Access Compliance Report

Public Rights-of-Way

(Curb Ramps)

Intersection ID: N/A	Main Street: S_CLARKSON_ST	Cross Street: DUNBAR_ST	Location: E
ADA ID: F18551FB6A91	Ramp Type: Perp	Initial Pass/Fail: Fail	Overall Compliance: No
Severity Score: 21.25			
Codes/Mitigation Info/Possible Solution		Field Measurements/Component Compliance

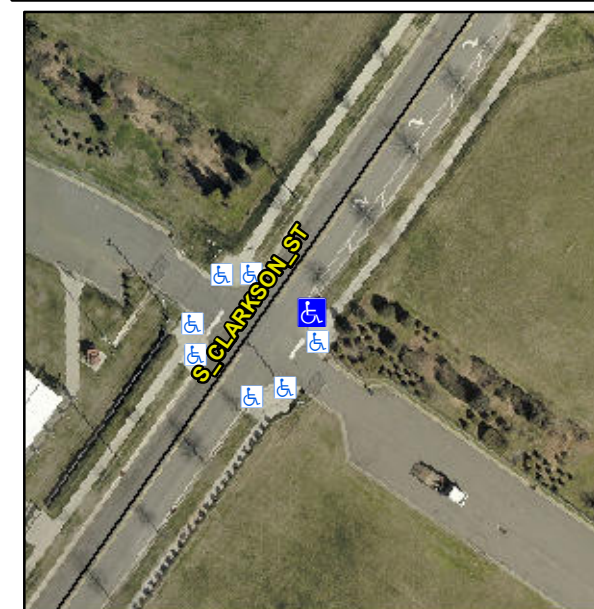
Not Found, R304.5.1, R304.2.2

Compliance	Description	Data	Compliance	Description	Data
N/A	Ramp Length (in)	95.0	No	Ramp Slope (%)	8.7
No	Ramp Width (in)	47.0	Yes	Ramp XSlope (%)	0.4
N/A	Flare Type LT	N/A	N/A	Flare Type RT	N/A
N/A	Flare Slope LT (%)	N/A	N/A	Flare Slope RT (%)	N/A
N/A	Flare Traversable LT?	N/A	N/A	Flare Traversable RT?	N/A
N/A	Landing Length (in)	N/A	N/A	DWS Provided?	N/A
N/A	Landing Width (in)	N/A	N/A	DWS Contrast?	N/A
N/A	Landing Slope (%)	N/A	N/A	DWS Length (in)	N/A
N/A	Landing X Slope (%)	N/A	N/A	DWS Full Width?	N/A
N/A	Landing Curb? (Y/N)	N/A	N/A	DWS Offset (in)	N/A
N/A	Shared Landing?	N/A			
N/A	Gutter Ponding?	N/A	N/A	Gutter Slope (%)	N/A
N/A	Gutter Lip Ht (in)	N/A	N/A	Gutter X Slope (%)	N/A
N/A	Painted X Walk1?	No	N/A	Painted X Walk2?	N/A
	X Walk 1 Direction	To NW		X Walk 2 Direction	N/A
N/A	X Walk 1 Width (in)	N/A	N/A	X Walk 2 Width (in)	N/A
	X Walk 1 Slope (%)	1.8		X Walk 2 Slope (%)	N/A
	X Walk 1 X Slope (%)	0.7		X Walk 2 X Slope (%)	N/A

Remove & Replace Entire Ramp.
